# GC0127 & GC0128:

**Mod Title:** EU Code Emergency & Restoration: Requirements resulting from System Defence and Restoration Plans

Figure 1.0

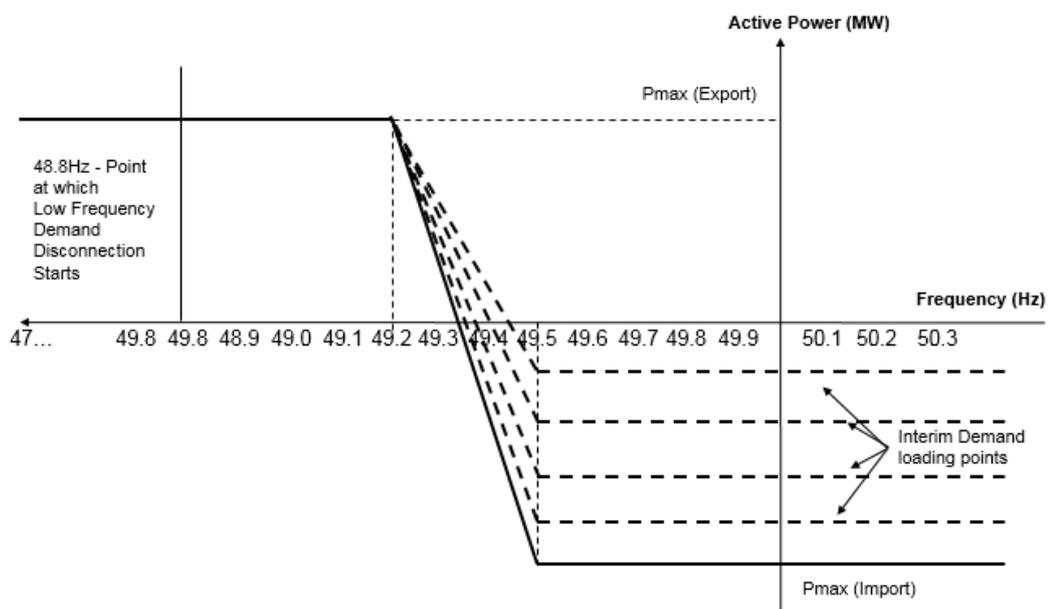
It is however important to note that E&R NC defines requirements for storage plant to be capable of switching from an importing mode to an exporting mode during periods of low frequency. This issue has not been addressed as part of the GC0096 Workgroup, although as part of this GC0127 modification initial consideration was given to this approach. The initial view of the Proposer was that a capability could be proposed as shown in Figure 1.0 below, however this was soon discounted on the basis of the variation in storage technologies, variable droop rates and unintended system consequences, whilst also noting that similar requirements do not apply to Pumped Storage or HVDC technologies. In addition, a separate (EU) Grid Connection Stakeholder Committee Expert Group was established in the autumn of 2018 to consider how the EU Connection Network Codes could be updated to consider the requirements for Storage. The requirements of Article 15(3) of (EU) Grid Connection Stakeholder Committee which relate to Storage were discussed as part of this Expert Group

As noted above, Article 15(3) E&R NC does state that the TSO shall set the time limit and active power set point for switching from an importing mode of operation to an exporting mode of operation. In GB, by setting the switching time to a short interval (1µs) the default option as defined in Article 15(3)(b) of the E&R NC would be for the automatic disconnection to take place. As GB System Operator, National Grid ESO would not wish all Storage plants to trip at the same time so the specific settings would be included within the Bilateral Agreement which would be consistent with the approach adopted for Pumped Storage.
